Addendum #4

Date: September 23, 2016

PROJECT #: HU-0027-B01
Harrison New Elementary School
Harrison Public Schools

DESCRIPTION: Addendum #4

SK-01 SCALE : 1/8" = 1'-0"

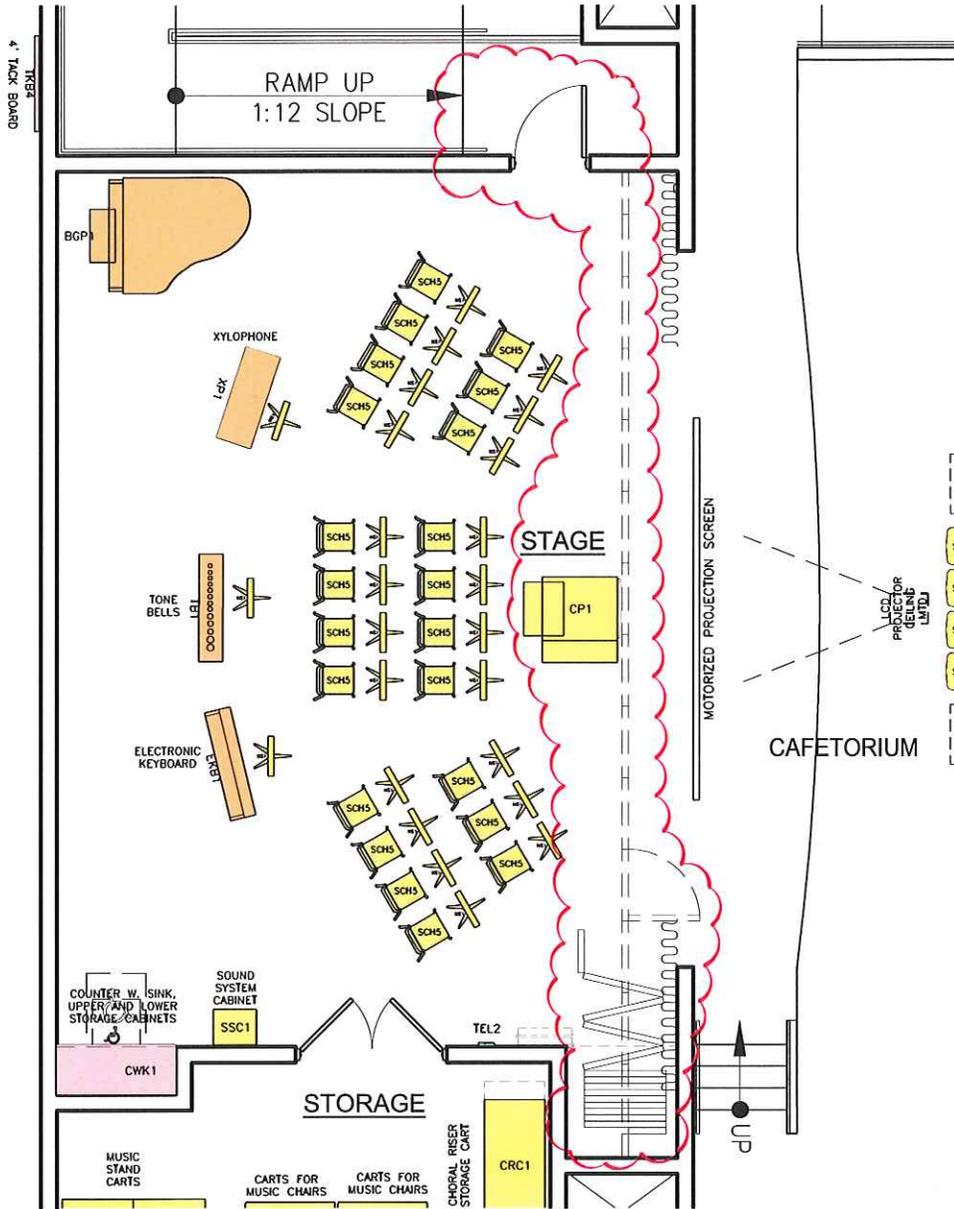
72. Question: Specification call for an electric folding wall. The drawing indicates a side stack folding wall which has to be manually operated. Also, the ceiling heights are not noted. Please advise.

Answer: See PS C1010.50 Interior Operable Partitions, paragraph I.A.1.a. Electric operation is required. Drawing A-101 1st Floor Plan is incorrect. See Drawing SK-01 Operable Partition at Stage, Partial First Floor Plan dated 21 September 2016 and attached to this Addendum as Attachment 4.1. A center stacked panel configuration has been substituted for the side stacked configuration. The door communicating between room C-112 Stage and the ramp to C-100 Corridor has been relocated slightly to accommodate the corrected configuration
